**SOLICITATION AMENDMENT  
MODIFICATION DE L'INVITATION**

<b>Title - Sujet</b> Chilled Water Pump Replacement	
<b>Solicitation No. - N° de l'invitation</b> EP635-180603/A	<b>Amendment No. - N° modif.</b> 001
<b>Client Reference No. - N° de référence du client</b> 20180603	<b>Date</b> 2017-08-11
<b>GETS Reference No. - N° de référence de SEAG</b> PW-\$\$HP-404-73103	
<b>File No. - N° de dossier</b> hp404.EP635-180603	<b>CCC No./N° CCC - FMS No./N° VME</b>
<b>Solicitation Closes - L'invitation prend fin</b> <b>at - à 02:00 PM</b> <b>on - le 2017-08-25</b>	
<b>F.O.B. - F.A.B.</b> <b>Plant-Usine:</b> <input type="checkbox"/> <b>Destination:</b> <input checked="" type="checkbox"/> <b>Other-Autre:</b> <input type="checkbox"/>	
<b>Address Enquiries to: - Adresser toutes questions à:</b> Michele Mak	<b>Buyer Id - Id de l'acheteur</b> hp404
<b>Telephone No. - N° de téléphone</b> (873) 469-3338 ( )	<b>FAX No. - N° de FAX</b> ( ) -
<b>Destination - of Goods, Services, and Construction:</b> <b>Destination - des biens, services et construction:</b> PWGSC Cliff Central Heating and Cooling Plant (CHCP) 1 Fleet Street Ottawa, Ontario Canada

This amendment 001 is raised to extend the closing date

**PUMP AND DRIVE  
 LOCATION DRAWING**

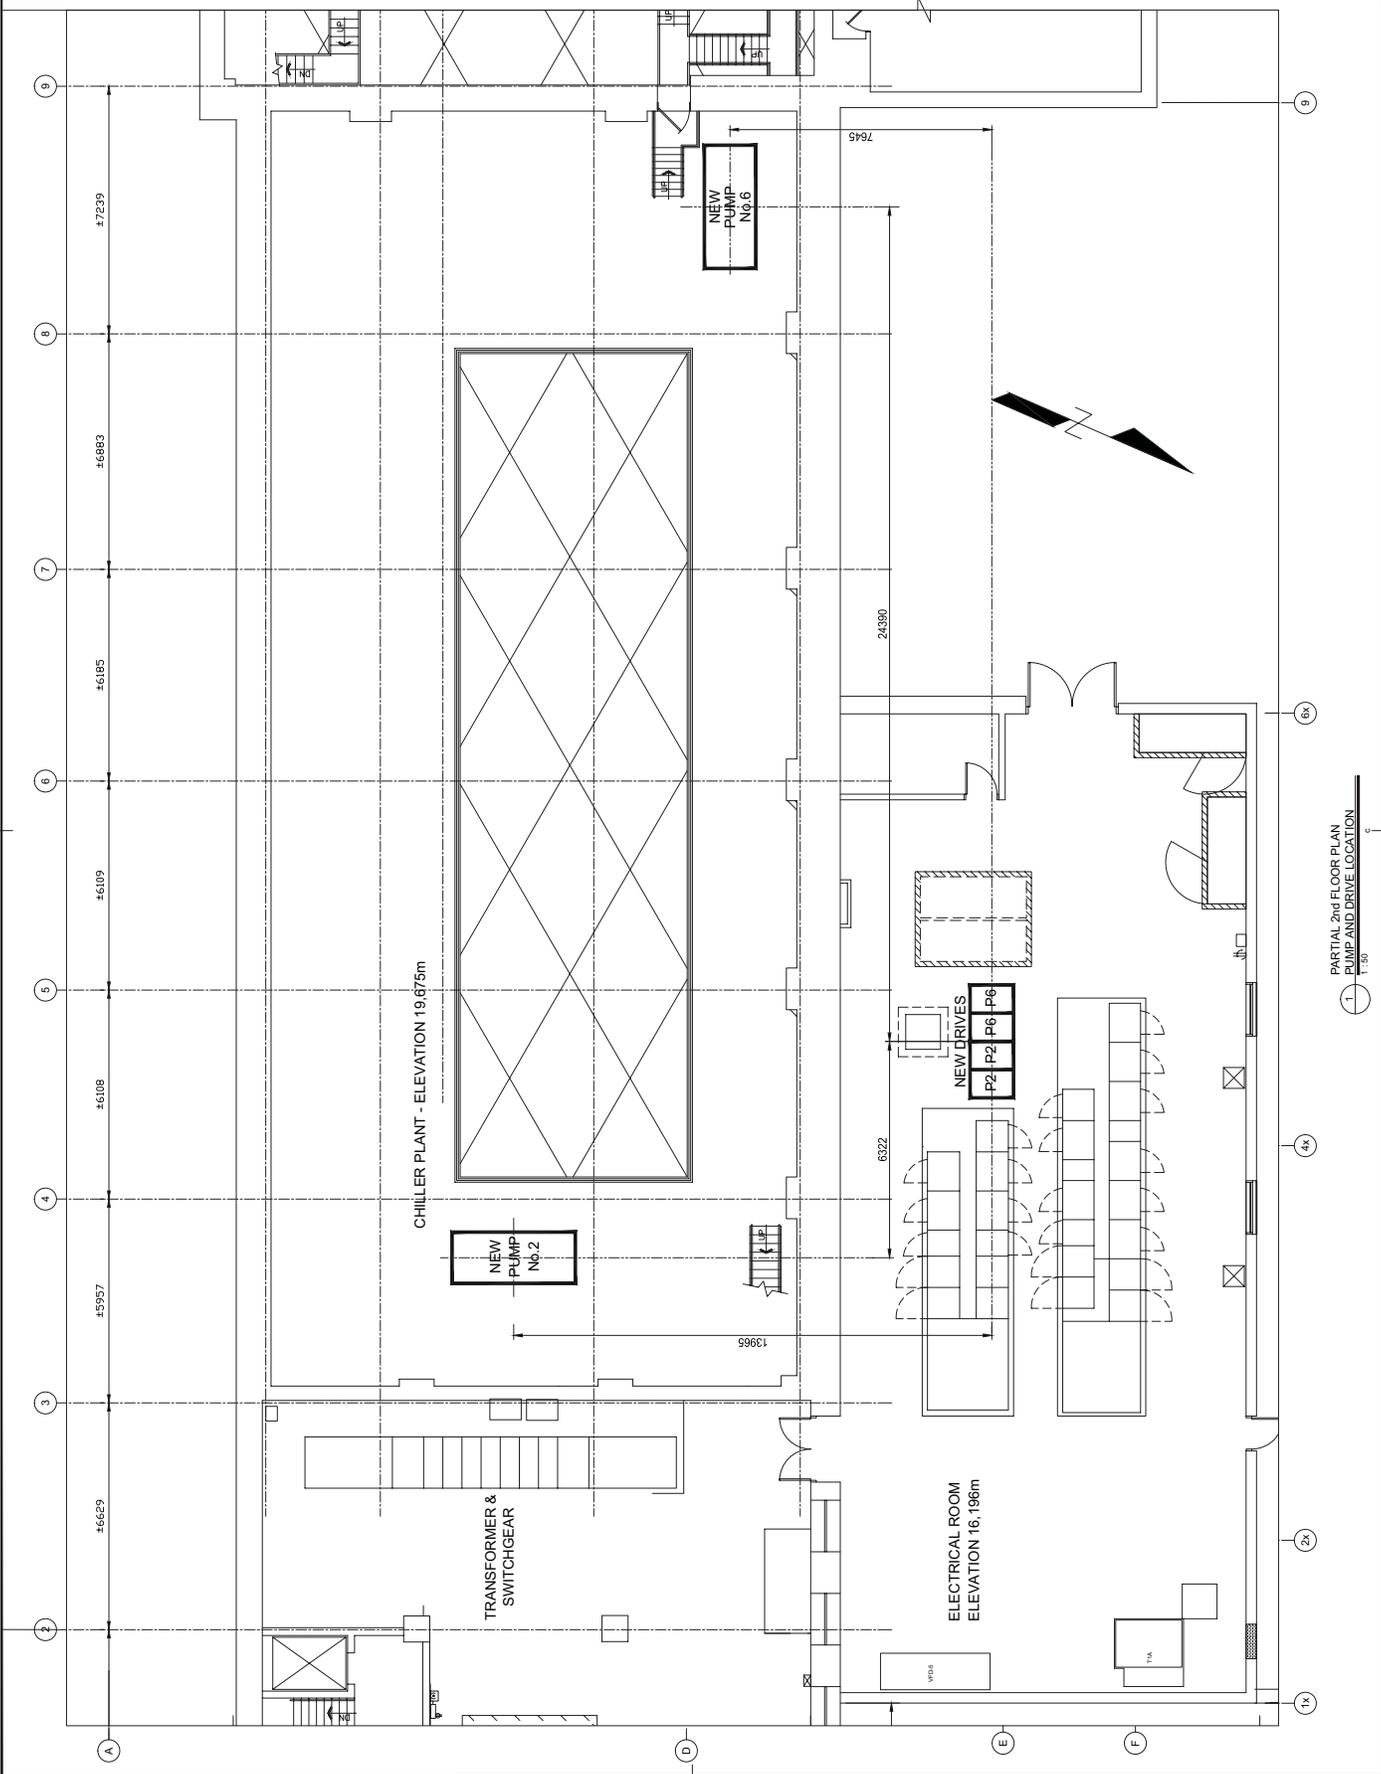
There is also reference to an electrical sketch that I could not locate in the package.

4) Add:

Sketch A0-1510789400-M-901

See Sketch A0-1510789400-M-901 attached hereto.

3.2.1 The Pumps will be located on the Chiller side of the Cliff Plant and inside the building, the drive controls will be in the electrical room – refer to attached sketch A0-1510789400-M-901 RevP0.
